Cyclists Touring Club right to ride network

04 July 2008

Hitchin Station Forecourt Redevelopment

Cycle Path Widths

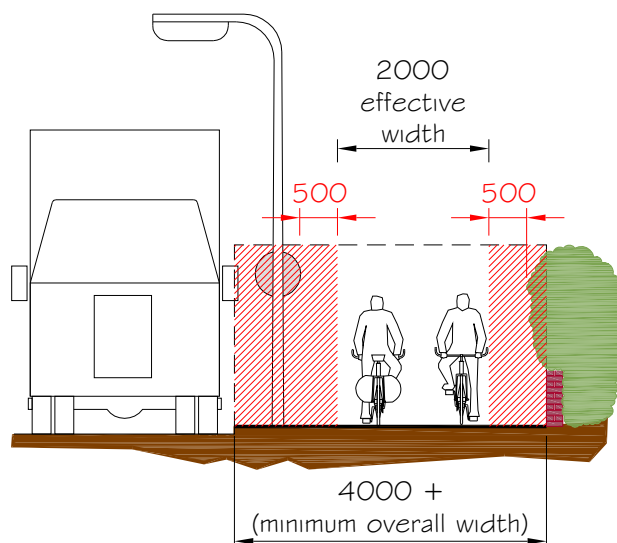
Note that the 2m minimum width shown is for cycle use only. 3m is the minimum width for shared use with 5m recommended.
